## JOINT REGIONAL PLANNING PANEL

<b>JRPP No</b>	2015SYE067
<b>DA Number</b>	DA-2014/283/C
<b>Local Government Area</b>	ROCKDALE
<b>Proposed Development</b>	Modification to mixed use development including conversion of ground floor plant room to commercial tenancy, increase in height of parapet and lift overruns, relocation of substation, addition of windows, increase to balcony sizes, addition of plant room to roof level, provision of shelter over lap pool and changes to materials
<b>Street Address</b>	286A, 294-298 Forest Road & 159 Frederick Street, BEXLEY NSW 2207
<b>Applicant/Owner</b>	Fox Johnston
<b>Number of Submissions</b>	Nil
<b>Regional Development Criteria (Schedule 4A of the Act)</b>	The proposal is a S96 Application to a development that has a capital investment value of more than \$20 million
<b>List of All Relevant s79C(1)(a) Matters</b>	<p>List all of the relevant environmental planning instruments; s79C(1)(a)(i):</p> <ul style="list-style-type: none"> <li>• Environmental Planning and Assessment Act 1979</li> <li>• SEPP 65 – Design Quality of Residential Flat Development</li> <li>• SEPP 55 – Remediation of Land</li> <li>• SEPP Infrastructure 2007</li> <li>• Rockdal

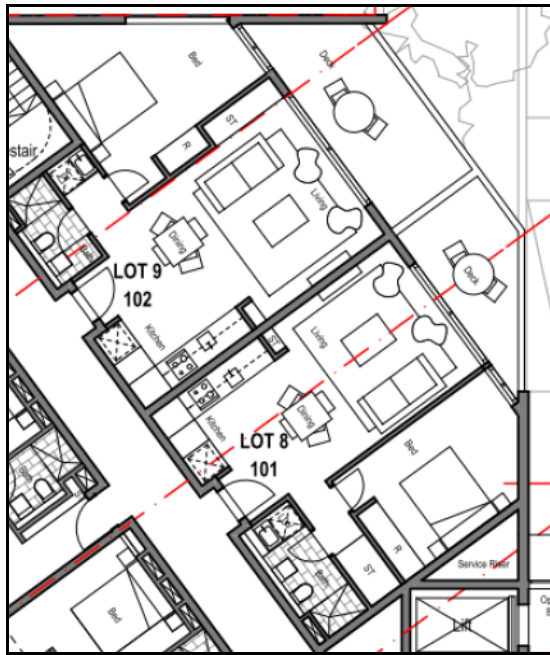
As a result, a total of 51sqm of approved landscaped area within the rear communal open space area of the site is reduced.

Notwithstanding is it noted that as approved the development comprised a total of 1078sqm (35% of the site) of landscaped area. This exceeds the minimum 25% required by DCP 2011.

The proposal as amended will retain compliance & exceed the DCP 2011 requirement providing 1027sqm (33% of the site) of landscaped area on site. The proposal is acceptable in this regard.

Units 101-102: As Approved

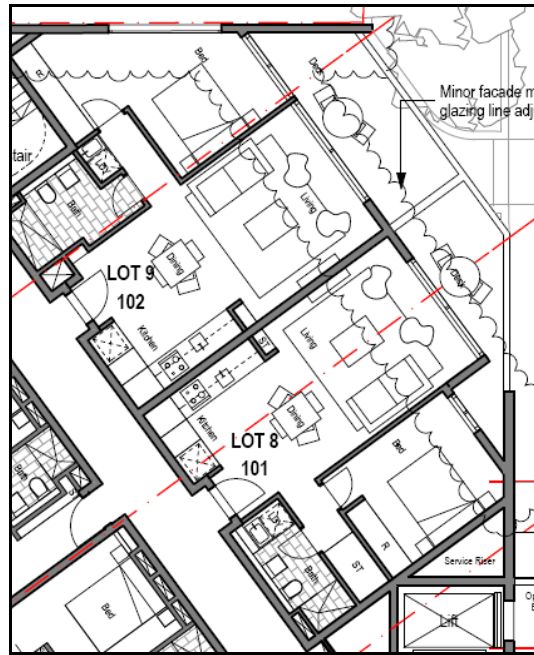
The size of private open space areas to units is modified as a result of minor changes to glazing lines, the introduction of a step to the building line at units 101-501 above & the use of slab levels at floors below.

Minor changes indicated above provide a logical bedroom layout avoiding the provision of storage and potential clutter adjoining glazed areas. Bathroom and laundry facilities are amalgamated, allowing a larger bathroom to be incorporated into units.

Units 501, 502, 503 - As Proposed

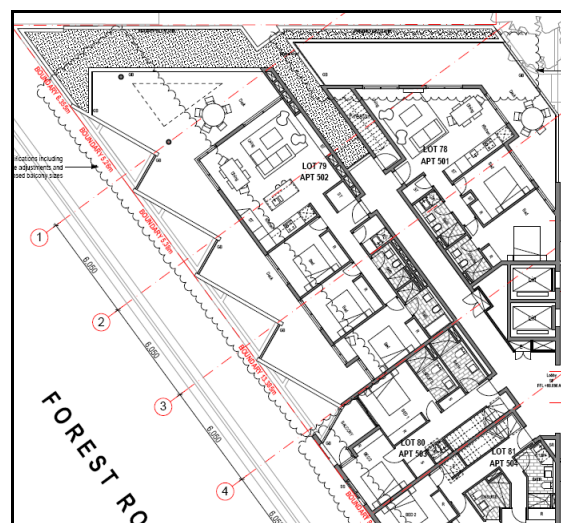
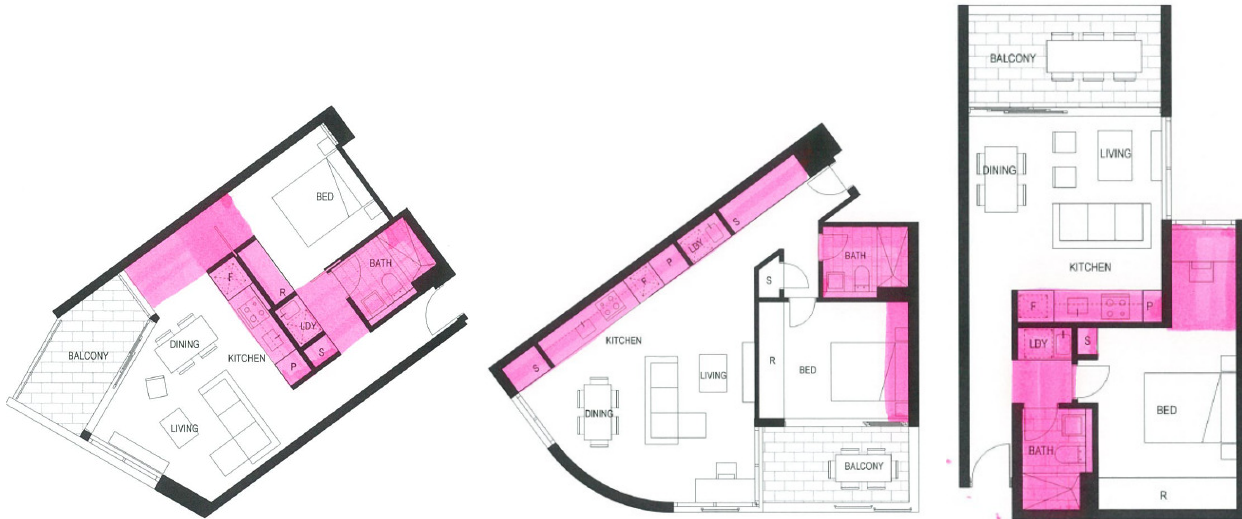
Units 501, 502 & 503 have been provided with an increase in balcony size, by making use of the slab of the floor level below. Given the orientation of these balconies to the NE & NW and their location adjoining living rooms and habitable areas this will result in increased amenity to these units.

*Finishes Schedule - As approved*

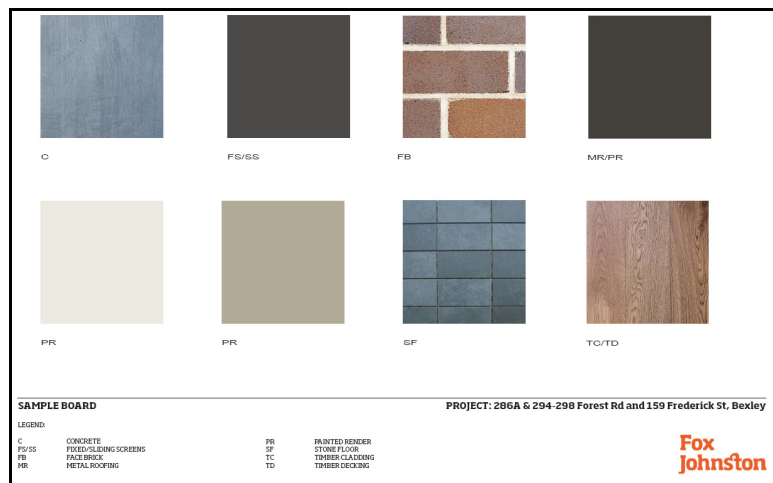
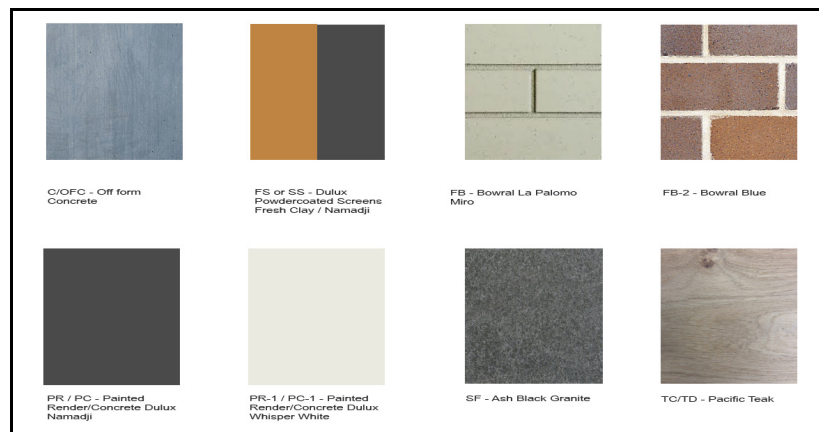
The proposal seeks to modify the approved colours, finishes and materials of the development.

As can be seen above the changes to the colours and finishes of the development incorporate additional brick colours, variations to aluminium powder coated screens & painted render, granite flooring as opposed to stone and minor change to the colour of timber decking. Modified colours and finishes are of a similar quality and calibre and are considered to be satisfactory.

*Sewer vent stack as viewed from northern elevation*

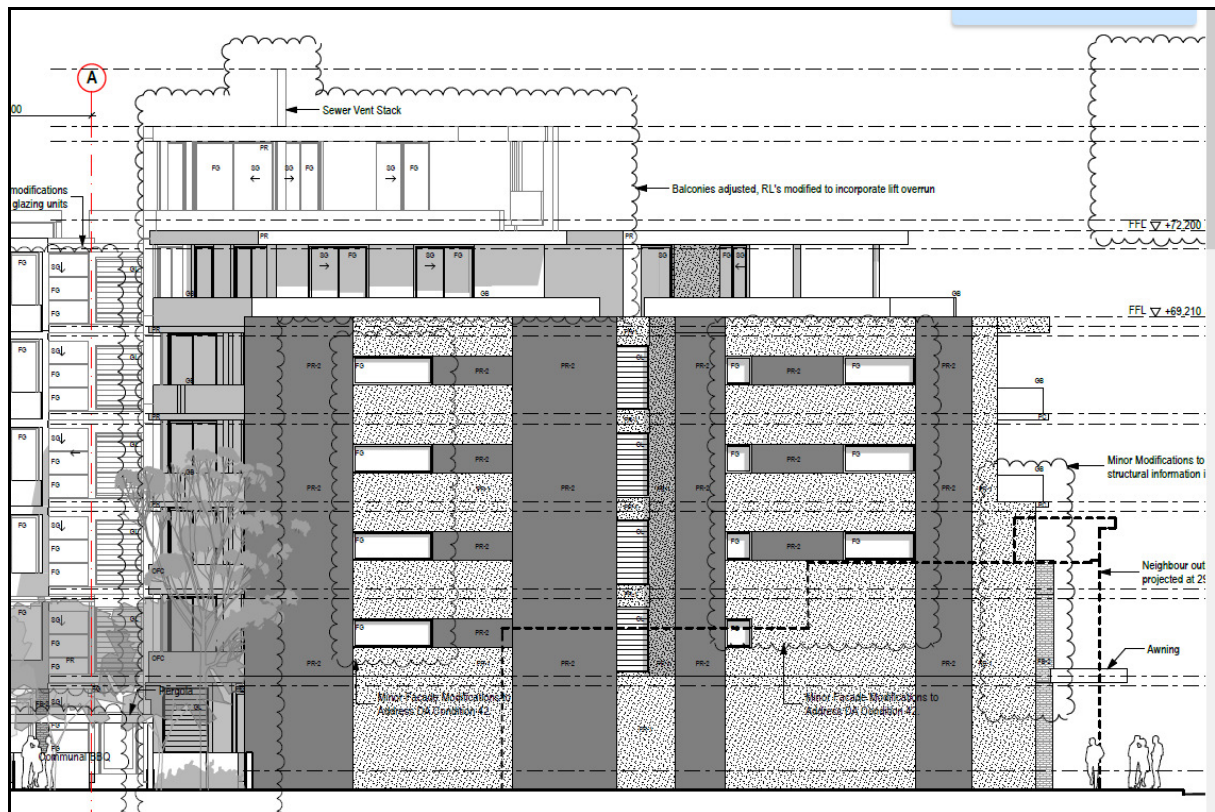
The proposal as modified increases the height of the parapet of the building component at the junction of Forest Road & Frederick Streets, by 0.47m to 75.810RL. This results in an overall building height of 22.7m on site to both the top of the parapet and lift overrun beyond.

Additionally a sewer vent pipe stack is required to be provided on site. This stack is integrated into the development and will rise 2m above the top of the building to meet the requirements of Sydney Water. The top of the sewer vent will comprise an RL of 77.810 AHD resulting in an overall height of 24.7m.
